**SECTION 00 90 01
BIDDING AND CONTRACT REQUIREMENTS
ADDENDUM NUMBER 1**

Issued: April 28, 2026

**Fire Tower Replacement
Issued for Bid**

Architect's Project Number: 25-028

SHEET NUMBER:
C-02

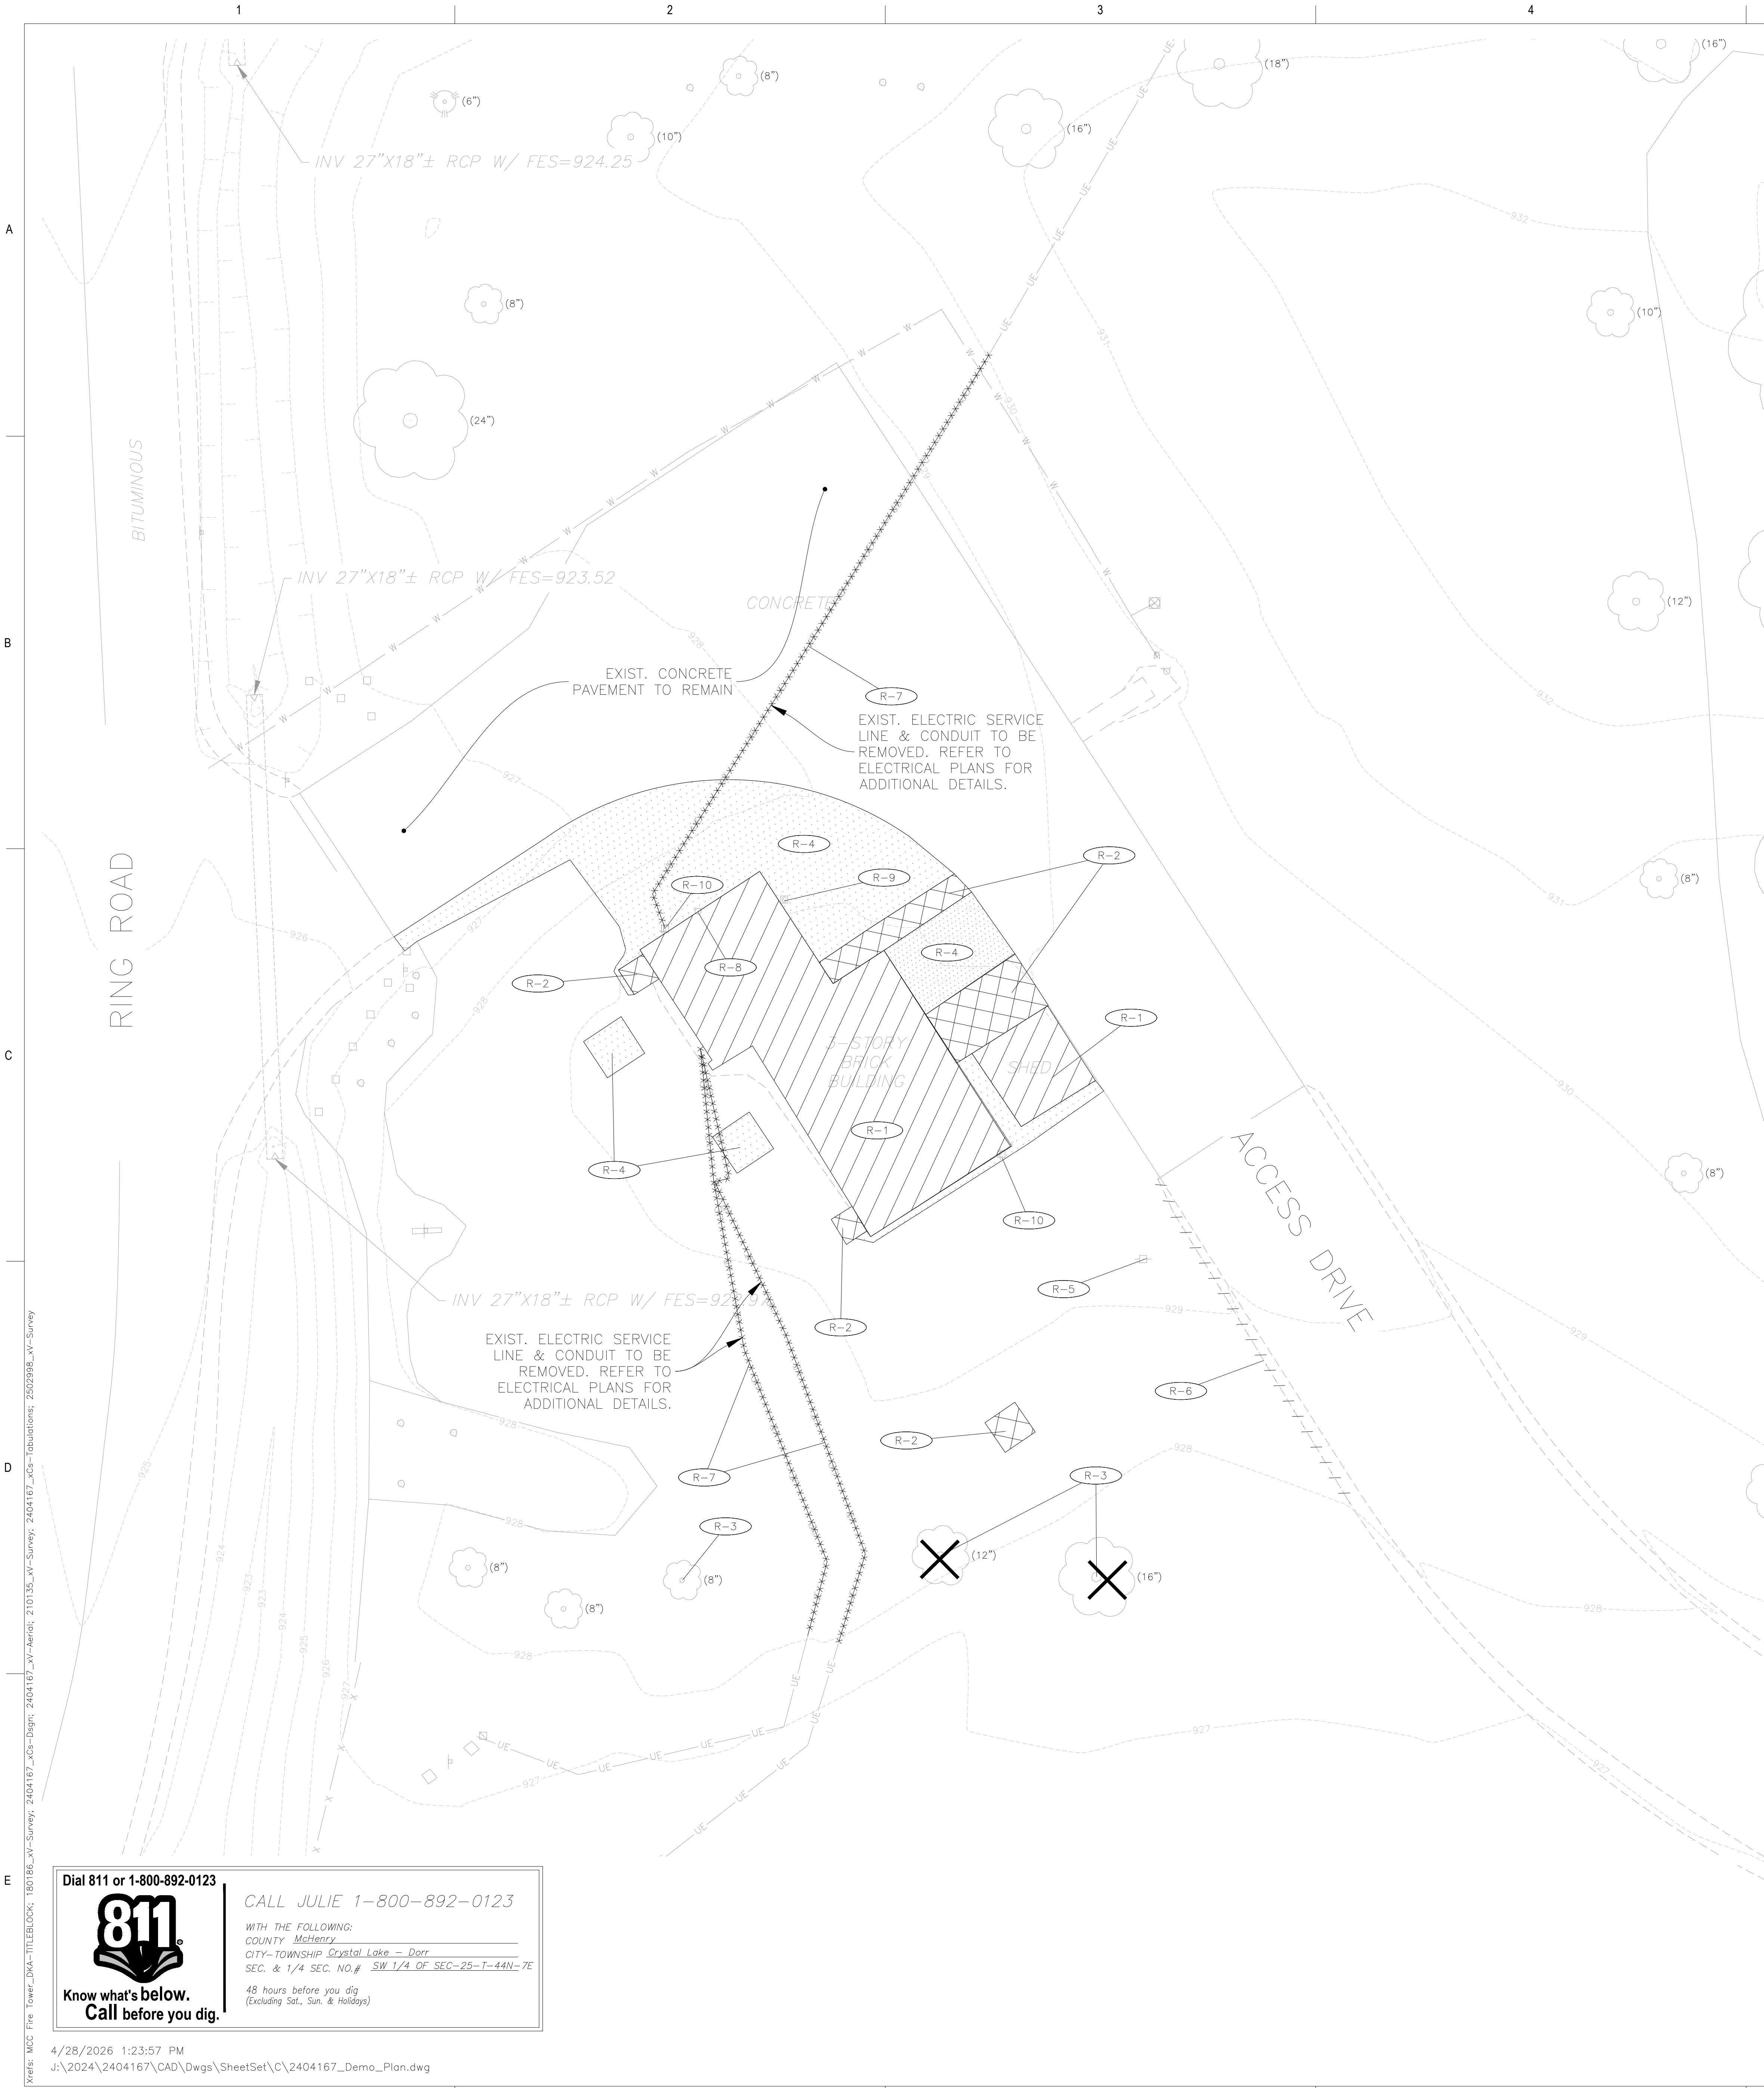
1. C-02
 - A. **ADD** limits of new radio tower access drive and associated note.
2. C-03
 - A. **ADD** bid alternate #3 note and limits of concrete removal & replacement.
 - B. **ADD** concrete pad around existing fire hydrant.
 - C. **ADD** concrete dumpster pad.
 - D. **ADD** concrete section detail for dumpster pad.
 - E. **REVISE** note for radio tower access drive.
 - F. **REVISE** bid alternate number for temporary radio tower access drive.
3. C-04
 - A. **ADD** concrete pad around existing fire hydrant & associated grading.
 - B. **ADD** concrete dumpster pad & associated grading.
 - C. **DELETE** backside of concrete ramps for both buildings.
4. C-05
 - A. **ADD** concrete pad around existing fire hydrant & associated grading.
 - B. **ADD** concrete dumpster pad & associated grading.
 - C. **DELETE** backside of concrete ramps for both buildings.

SHEET NUMBER:
A4.00

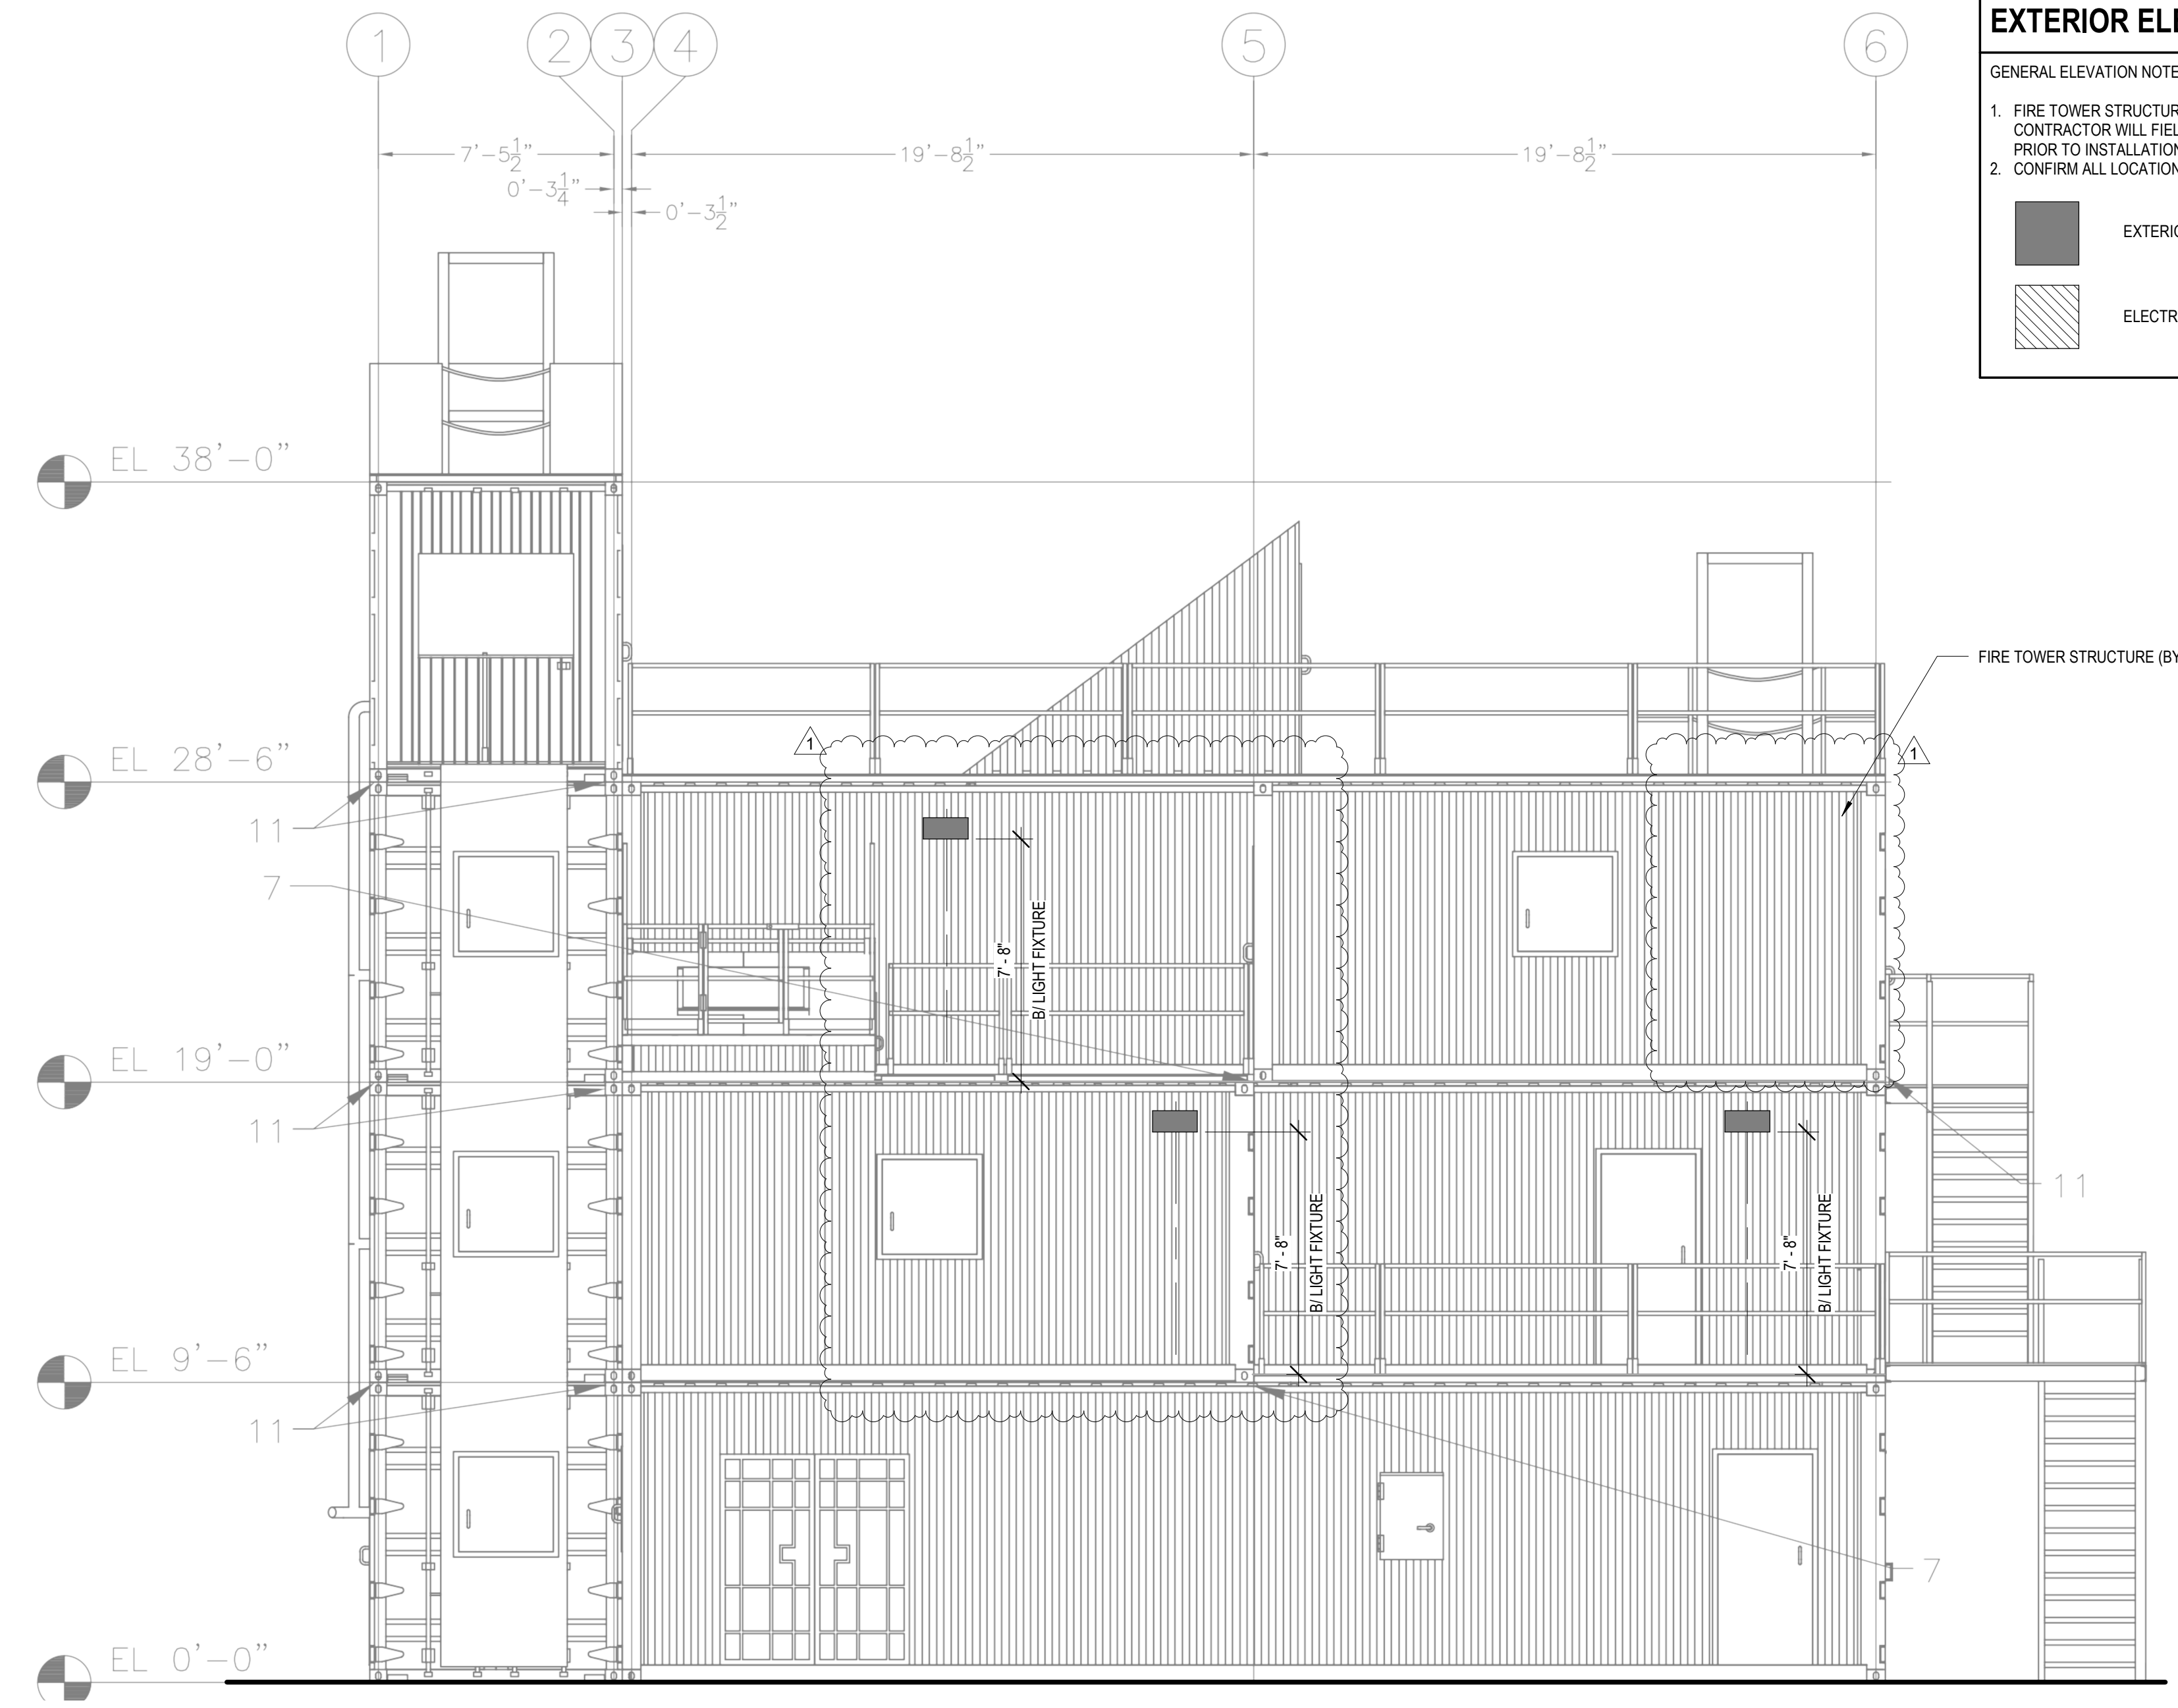
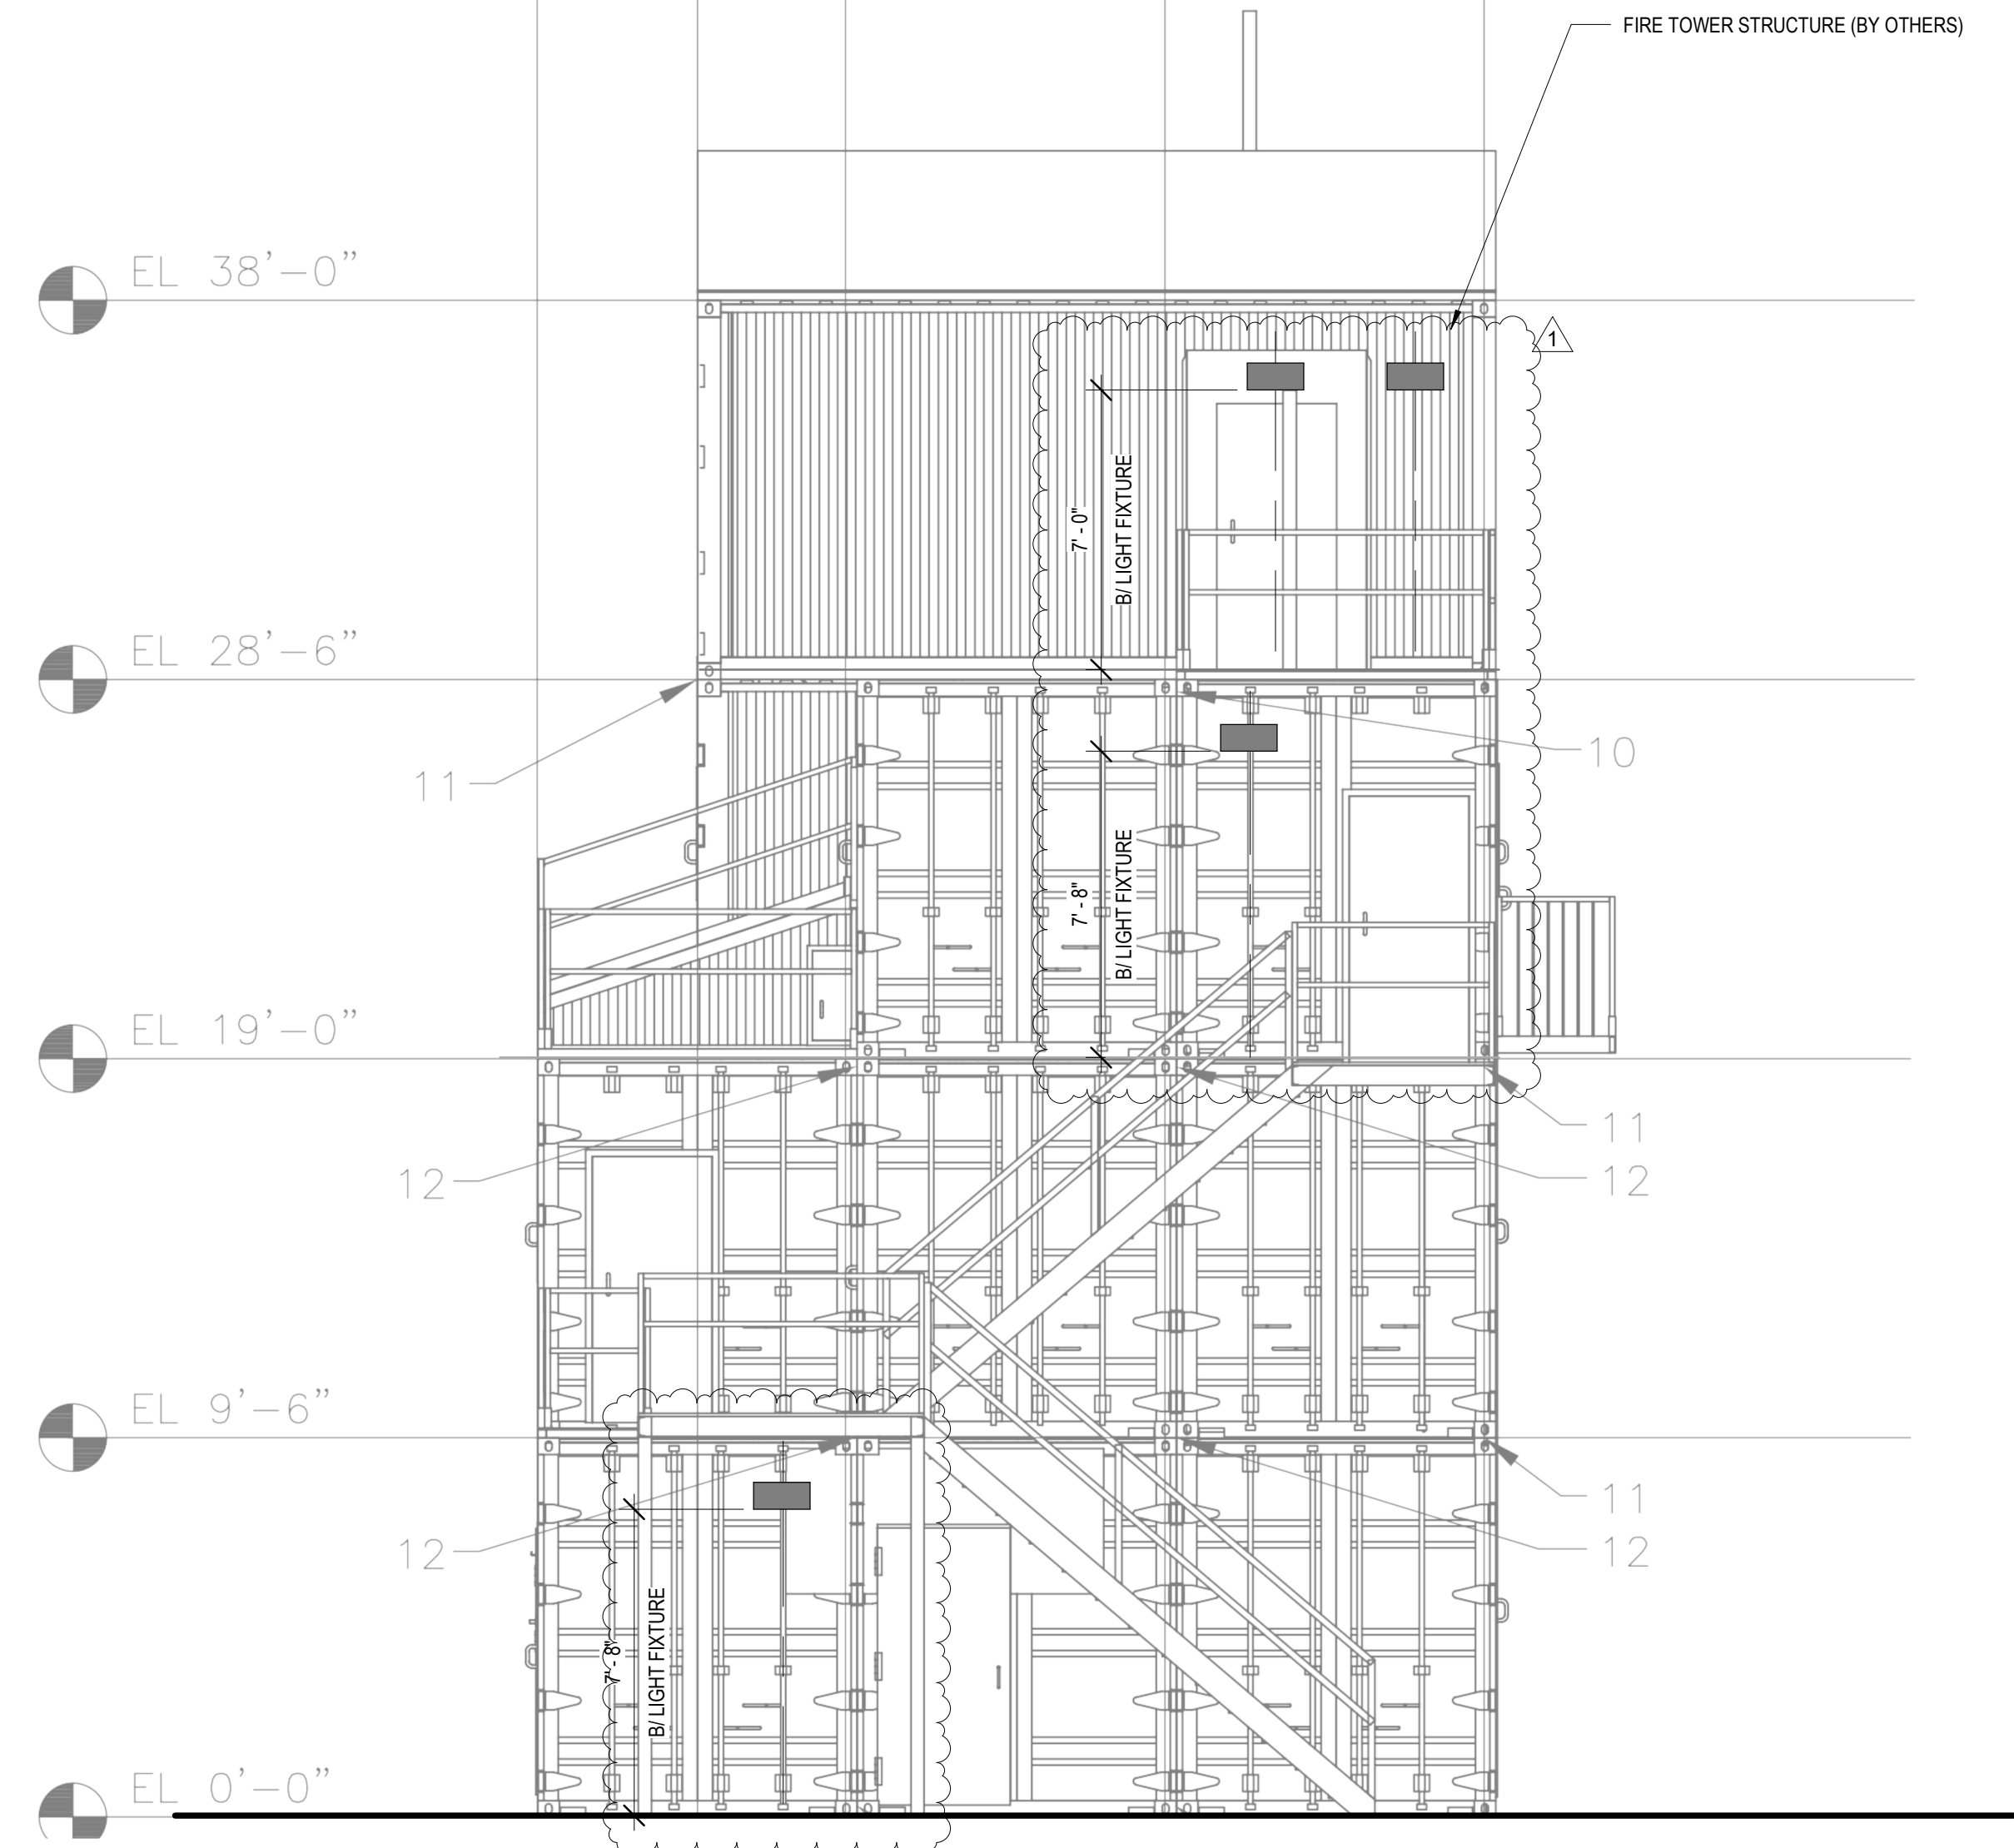
2. A4.00
 - A. **REVISE** exterior lighting locations on all elevations. See Electrical drawings.
